| Well Name: CHACO PLANT | Well Location: T26N / R12W / SEC 17 / NWNE / 36.492935 / -108.131332 | County or Parish/State: SAN JUAN / NM |

Sundry ID: 2714704

| Type of Submission: Notice of Intent | Type of Action: Plug and Abandonment |

Attachment to notice of Intention to Abandon

Current P & A Wellbore

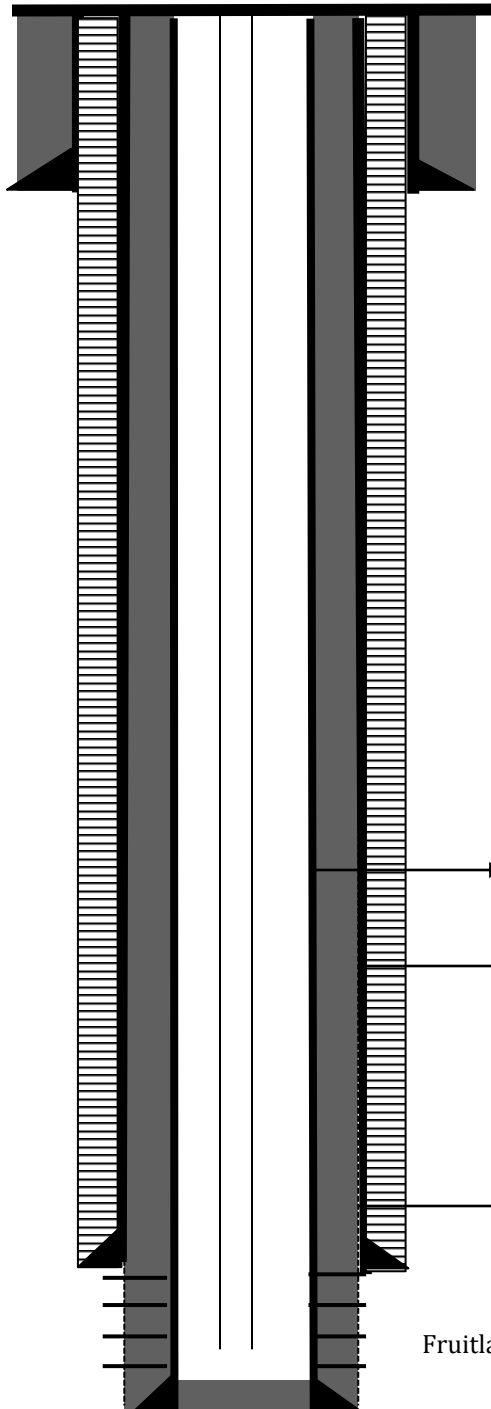
1. Plugging operations authorized are subject to the attached "General Requirements for Permanent Abandonment of Wells on Federal and Indian Lease."
2. The following modifications to your plugging program are to be made:
 - a. Recommend running CBL to determine TOC 7" and 4-1/2" casing strings (cement not circulated to surface). Change plugs to inside/ outside as necessary based on CBL.
3. Farmington Office is to be notified at least 24 hours before the plugging operations commence at (505) 564-7750.

- Sundry ID: 2714704
- No well log for subject well. Operator tops are acceptable based on logs from Reference Well #1.
- Recommend running a CBL to determine TOC between 7" and 4-1/2" casing strings (cement not circulated to surface). Change plugs to inside/outside as necessary based on CBL.
- Fruitland Coal perfs 1147' – 1167'.

Planned P & A Wellbore

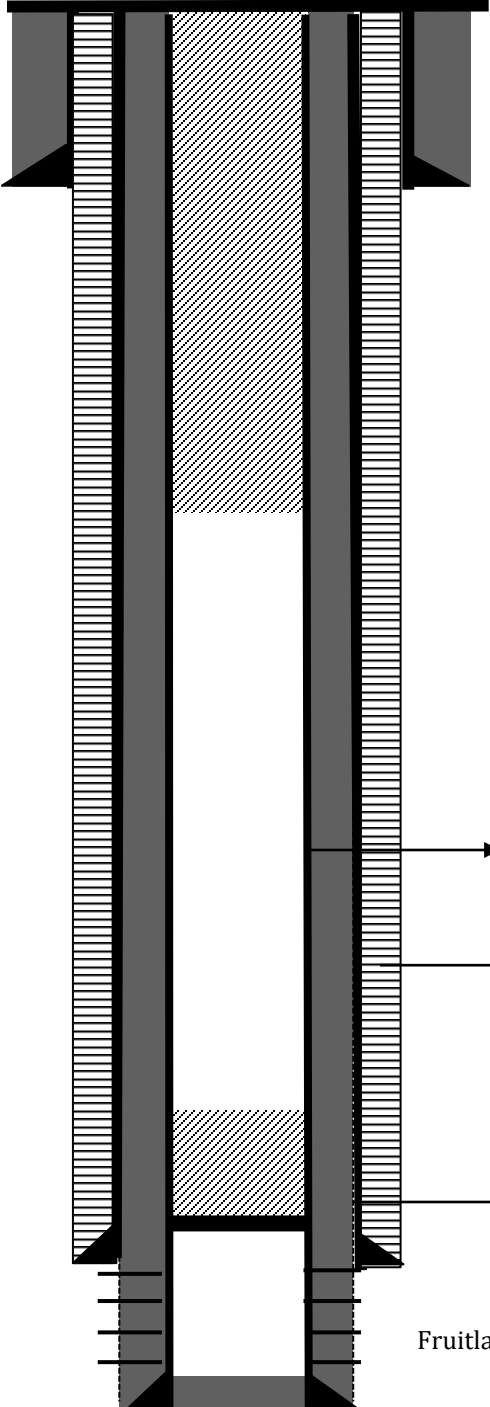
You are also required to place cement excesses per 4.2 and 4.4 of the attached General Requirements.
